**LEESBURG BOARD OF ARCHITECTURAL REVIEW
STAFF REPORT**

**CONCEPT REVIEW: 19 NOVEMBER 2012
AGENDA ITEM 4b**

BAR Case No. THLP-2012-0127: Modifications to existing building at 6 W. Market St. differing from approved Certificate of Appropriateness TLHP-2012-0039.

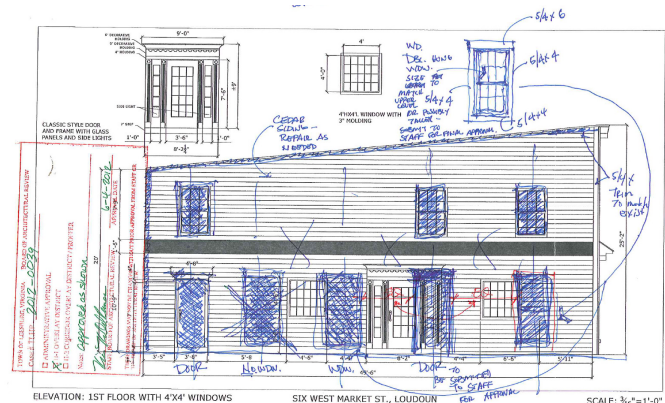
- (1) The owner has installed a Greek Revival door surround with pilasters with Corinthian capitals and a large pediment above a side entry door. The previous approved certificates of appropriateness, TLHP-2009-0096 granted in 2009 and TLHP-2012-0039 granted earlier this year showed a much simpler entry door and added windows all the same size to make the elevation more symmetrical and balanced.
- (2) The owner has installed lighting fixtures on the front elevation without approval
- (3) The owner requests to add brick to the lower edge of the side elevation and a brick sidewalk and to paint the building black with a gold painted trim, samples are in staff's office and will be brought to the meeting

- (1) The COA granted in 2012 stated that the door, surround and trim was to be approved by staff as the owner was looking for a salvaged door and did not have an example to be approved at that time. The owner installed the present door and staff approved it in place as appropriate, however, staff advised the owner that the surround should be simple, small enough to only cover the door and have no sidelights as this was a side entry and not to change the orientation of the building as is stated below in the guidelines:

When it was discovered the work in progress was not in compliance with the approved COA, staff visited the site and contacted Mr. O'Conner, from the site, to advise him of the fact that the door surround being built was not approved and not appropriate. The owner advised he would not have his carpenters stop the work but would rather have the BAR to decide the appropriateness of the finished product

- (2) The new period light fixtures may be compatible in general with the facade, but the large light fixture is out of scale with the other light fixtures and should be the same size as the smaller fixtures.

- (3) Using brick on the lower façade will create the illusion that there is a brick foundation will give the brick façade on the front of the building more importance, is not historically accurate and will change the historic appearance of the building. The applicant stated the wood rots at the bottom edges of the building on the side due to the traffic and exposure. Staff suggested cement fiber board to match the wood siding on the bottom row or two in the same color which would be far less noticeable than a materials change to brick.

Gold is specifically mentioned as not appropriate for buildings and the use of gold for all trim would constitute an overabundance of colors on details that would overwhelm the building. The use of black as a main body color is obtrusive given the context of the building along Market Street. Unless a historical precedent can be provided that black had been a main body paint color on this building or another on

1. The large light fixture be replaced with a smaller version of the same fixture
2. The door surround is removed and the pediment is replaced with a smaller pediment that is only above the door as is shown in the applicant's most recent drawing and siding is to be patched where it was removed for this door surround
3. The lower edge of the side elevation may have the bottom two rows of wood siding replaced with a closely matching fiber cement siding painted to match the existing siding
4. A dark traditional color, such as green, brown or blue is chosen for the main body of the building that is compatible with the brick
5. A contrasting traditional trim color is chosen that is compatible with both the new main body color and the existing brick
